Evaluation of proposed move for Water Right No. 28234

Proposed: Move water right no. 28234 ID3 to the well authorized under 28234 ID2, 710 ft to the east. This change does not meet spacing requirements under GMD3 rules. A waiver of spacing rules will be required if the move is to be approved.

Data Set: C:\Users\trevora\Documents\2022_moves\28234\28234 Current.aqt

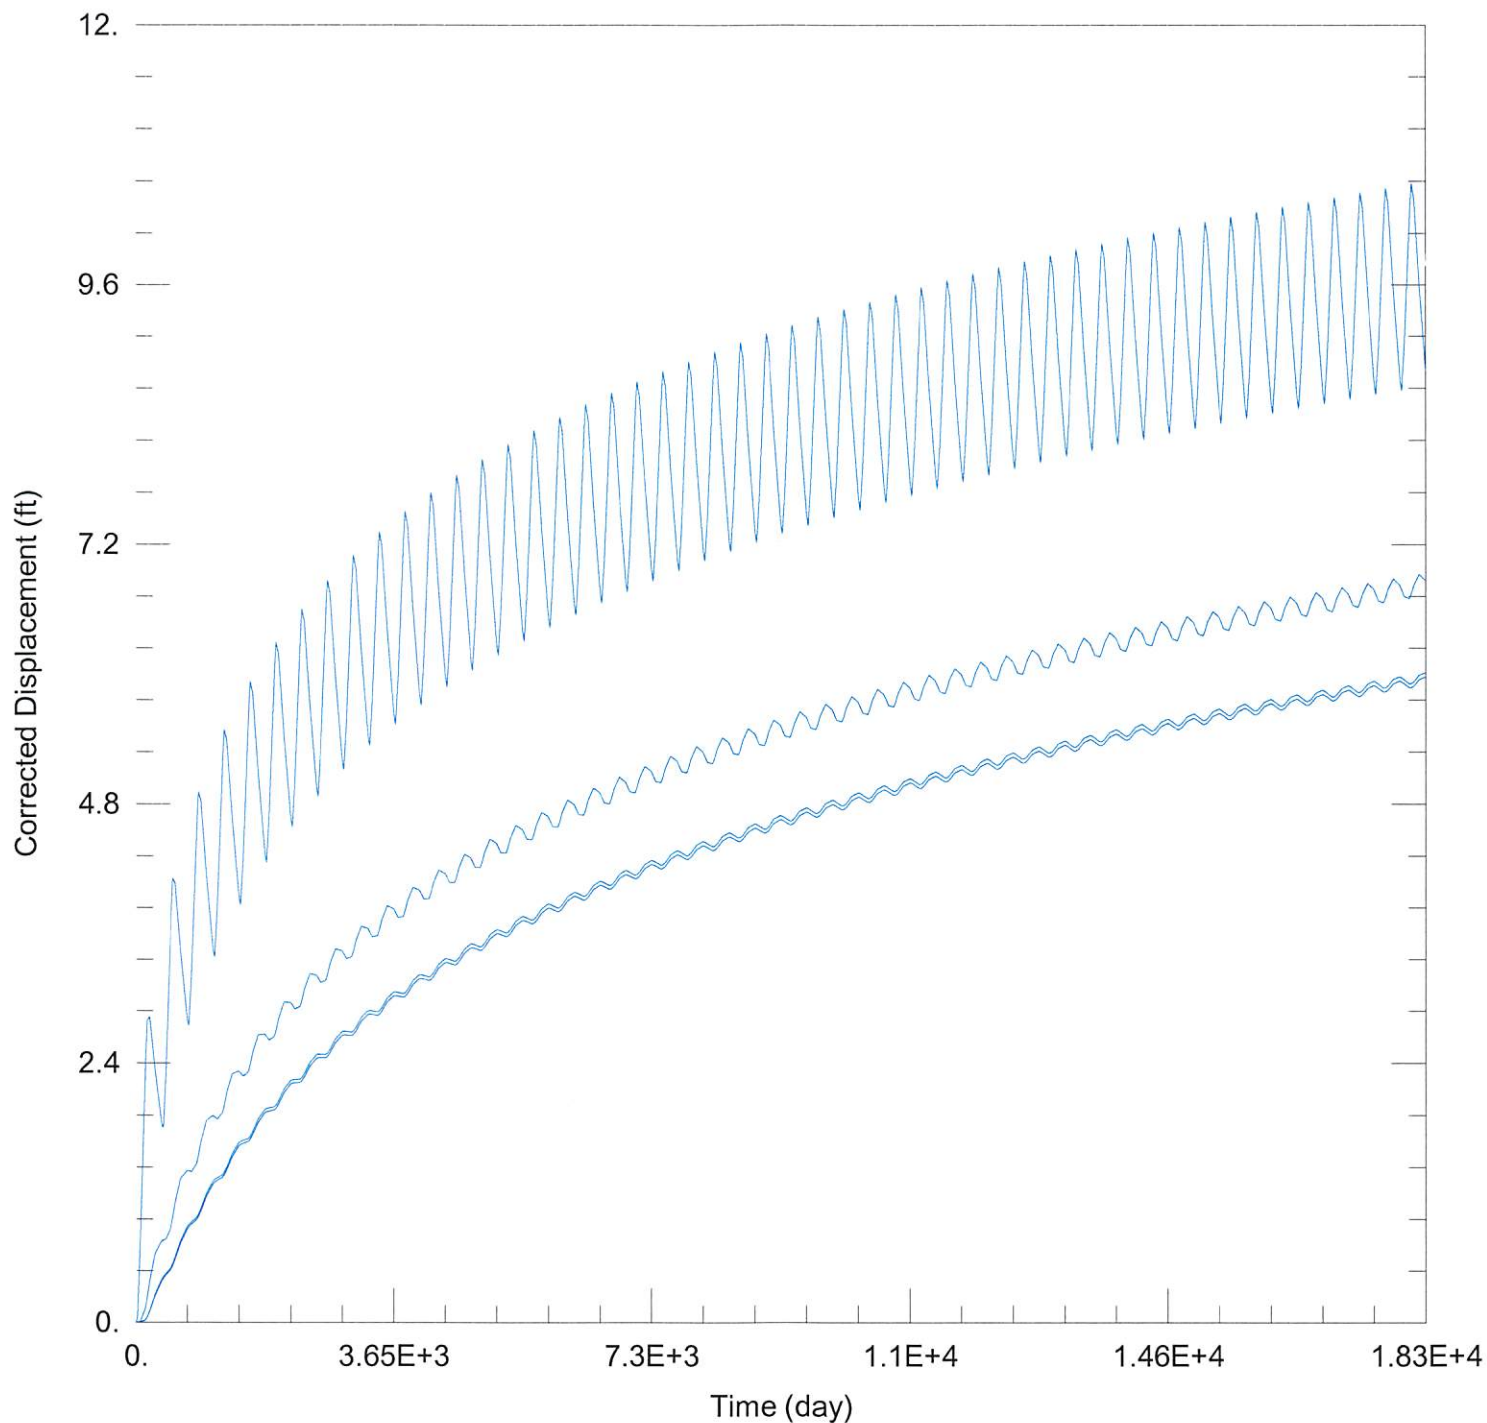
$S = 0.1931$, $T = 2266.9 \text{ ft}^2/\text{day}$, $tp_{\text{current}} = 137 \text{ days}$, $Q_{\text{current}} = 790 \text{ gpm}$, $tp_{\text{proposed}} = 233 \text{ days}$, $Q_{\text{proposed}} = 1050 \text{ gpm}$

| 28128: | Drawdown from current location = 5.97 ft |
| | Drawdown from proposed location = 13.45 ft |
| | Net drawdown = 7.5 ft |

Net drawdown exceeds the drawdown allowance of 1.5 ft for all wells within 1 mile of the proposed location. Critical well analysis is necessary on those wells.

Data Set: C:\Users\trevora\Documents\2022_moves\28234\28234 Proposed.aqt

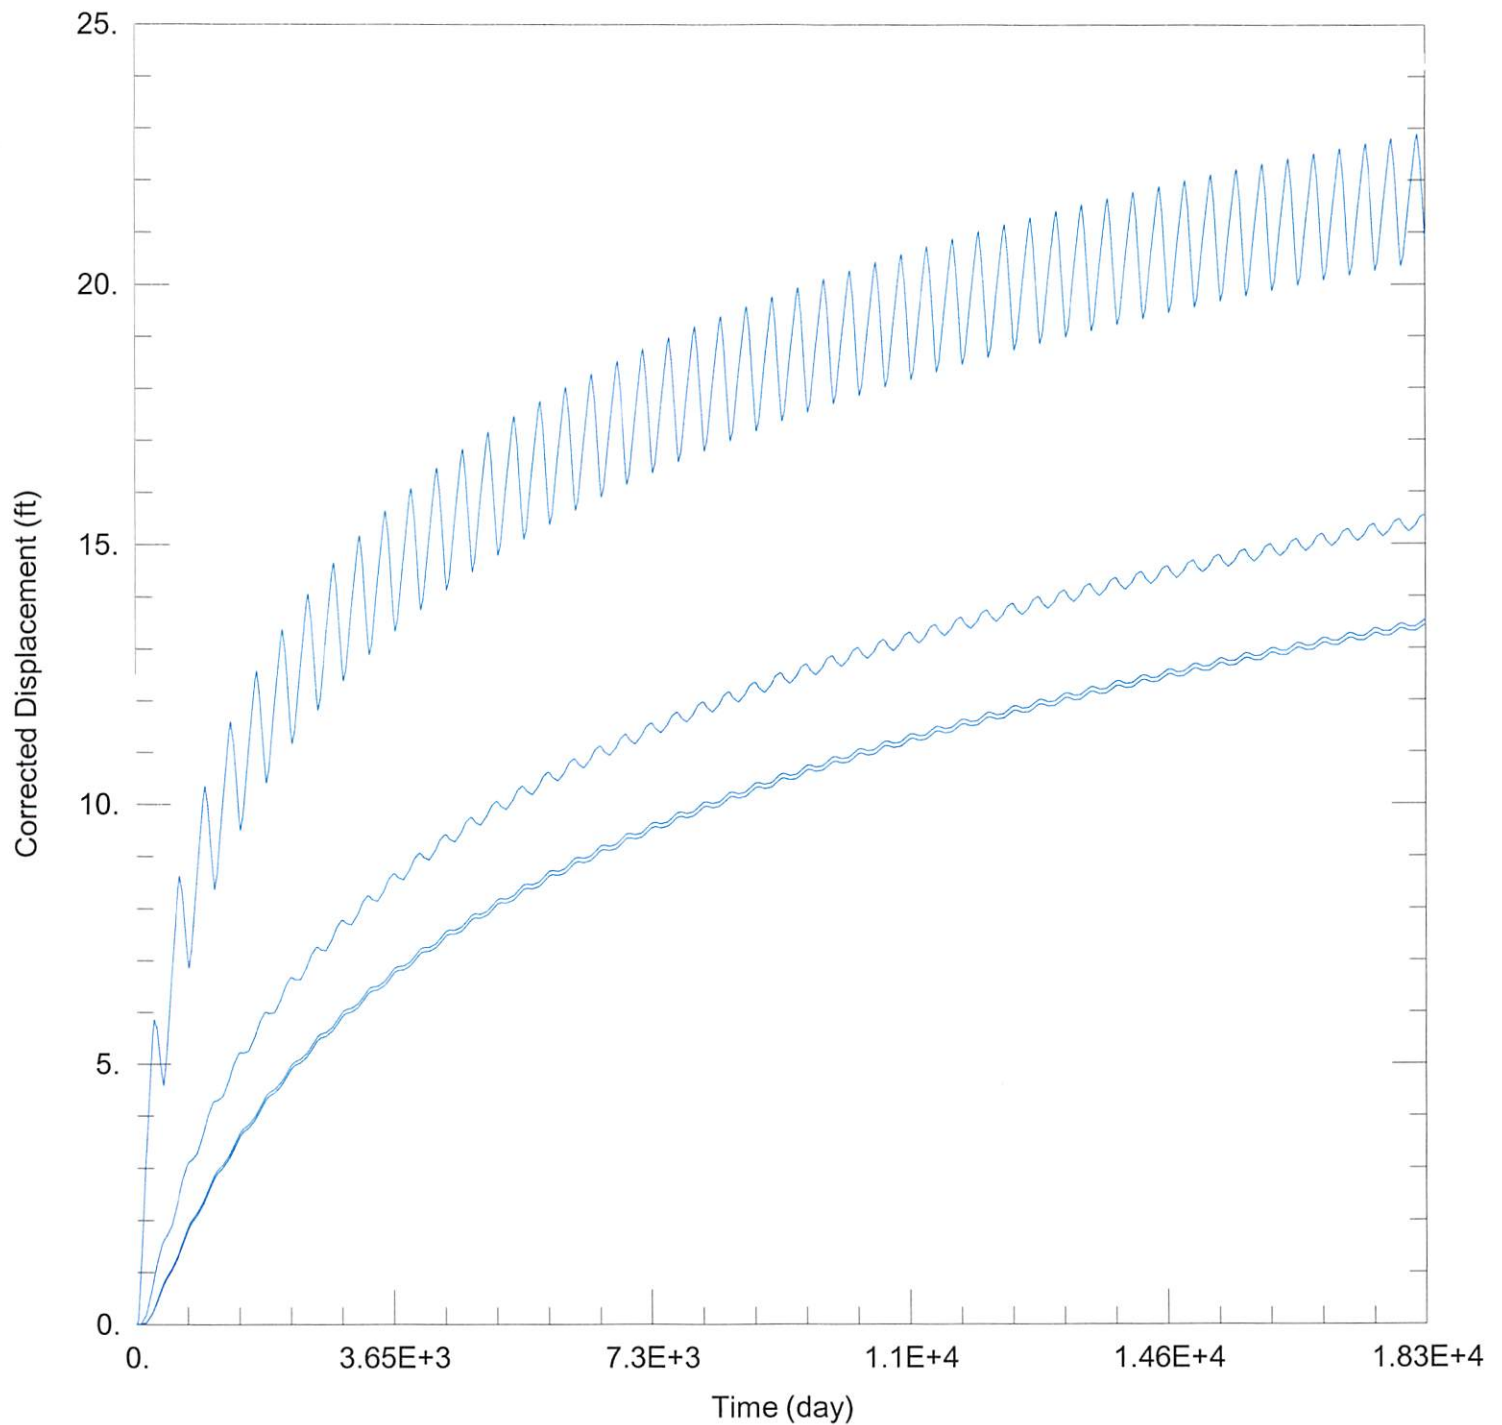
| | Drawdown from proposed location = 13.54 ft |
